# New Project Proposal: Reopen SFF-TA-1002

Presented: 1/23/2026

# New Project Proposal: SFF-TA-1002 R1.6

# External Feedback on dimensioning

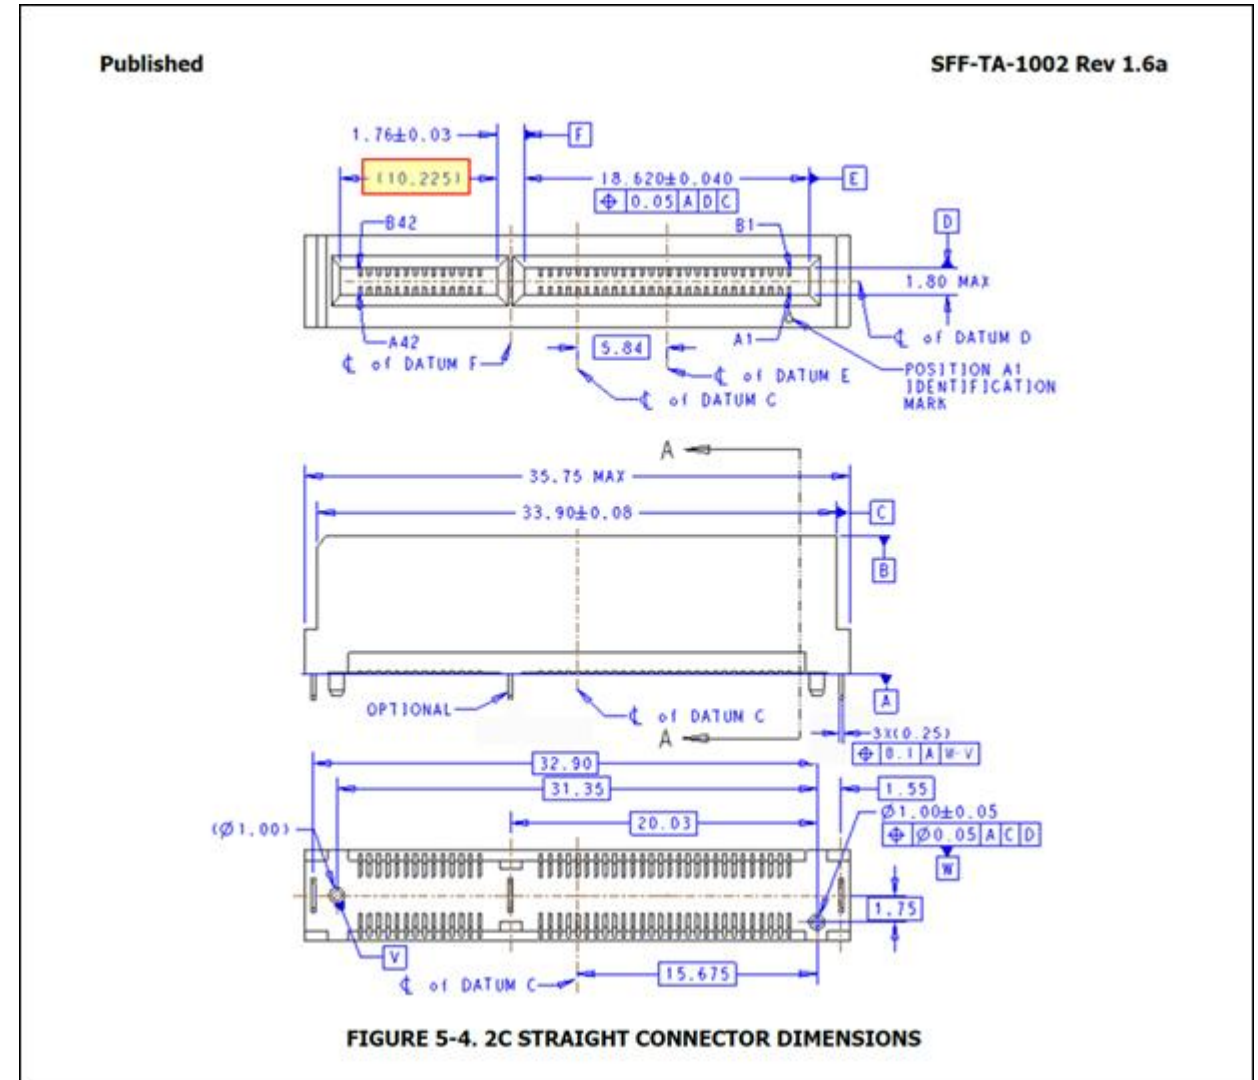
- Looking at Figure 5-4, the width of the second receptacle is dimensioned with a reference dimension, width of (10.225). From where is this dimension derived?

**FIGURE 6-1. CONNECTOR ELECTRICAL CURRENT TRANSIENT SUPPORT.**

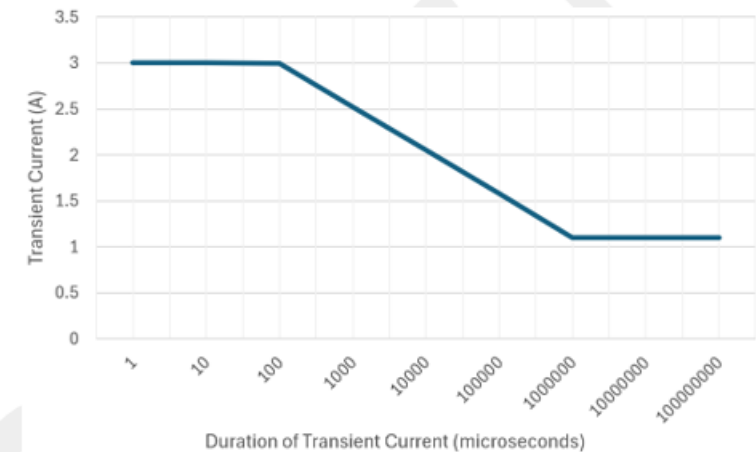
- Concern received on the test profiles. Are they needed?
  - Maybe okay with the static profile testing since the RMS is not supposed to exceed static value (1.1A/pin).
